SIB 12 03 20

SERVICE ACTION: INSPECT AND SECURE THE ENGINE ELECTRICAL HARNESS

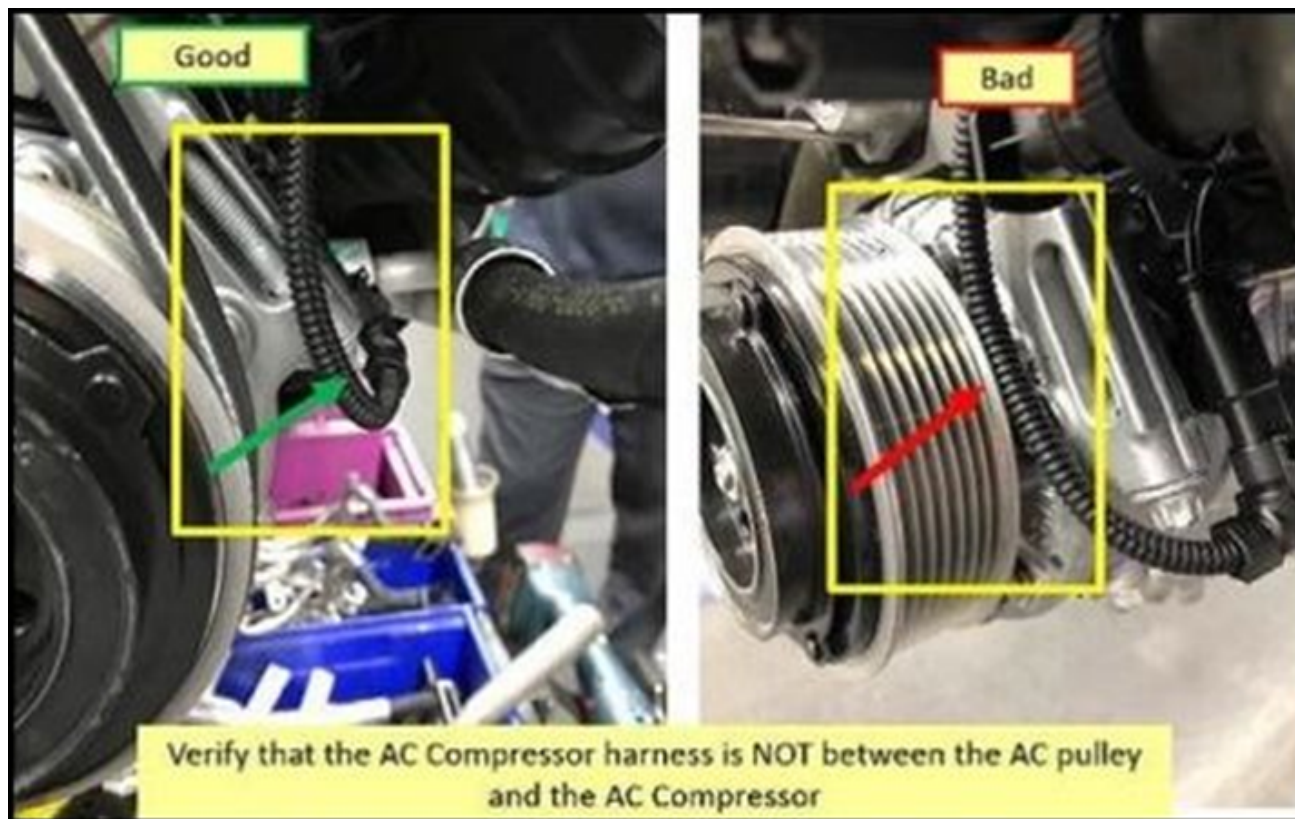
An improperly routed engine wiring harness may become damaged if it contacts the air conditioning (AC) compressor pulley.

Incorrect routing of the engine electrical harness during assembly.

Inspect the engine harness and secure or replace as needed.

- o The wiring harness must be replaced. Ensure the replacement wiring harness is properly routed as shown to the left. The heat-resistant cable tie is not needed if the engine harness is replaced and properly routed.

Secure the wiring harness to the air conditioning refrigerant line as shown below.

Note: Only the heat-resistant cable tie must be used to secure the wiring harness to the metal crimp of the air conditioning refrigerant line as shown above.
